FIELD OBSERVATION REPORT

Central Hardin High School – Phase 2, 2019111 -CA8

Report No: 49

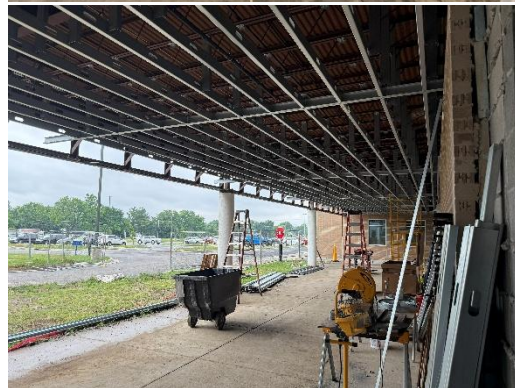
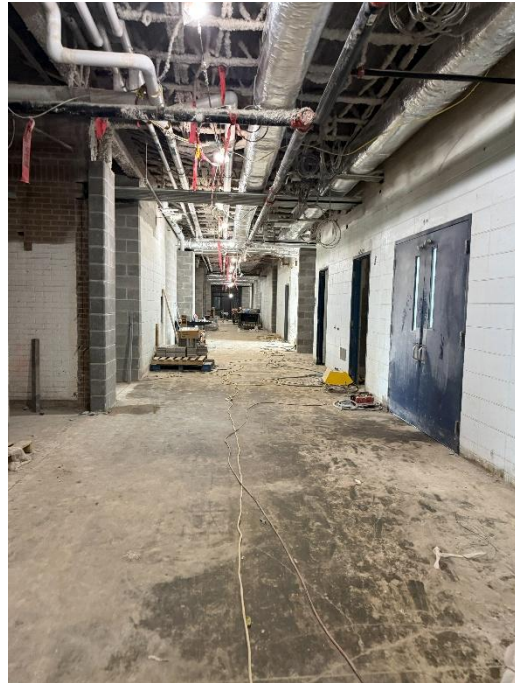
- a) Having rock on the new parking area allows for continued access to the site after storms like occurred in the area.
- b) The exposed areas of soil were still wet from the storm.

- c) Storm water had been pumped from the footing excavations.
- d) Preparations were made before the storm to pour the first-floor corridor slab in Area G. This pour was rescheduled for 6-11-2026 due to the rain on Monday.
- e) Welded wire fabric on chairs was in place for the corridor slab.
- f) The spray foam insulation over the exterior wall of the kitchen has been exposed for an extended time. This needs to be examined before it is covered with bricks.
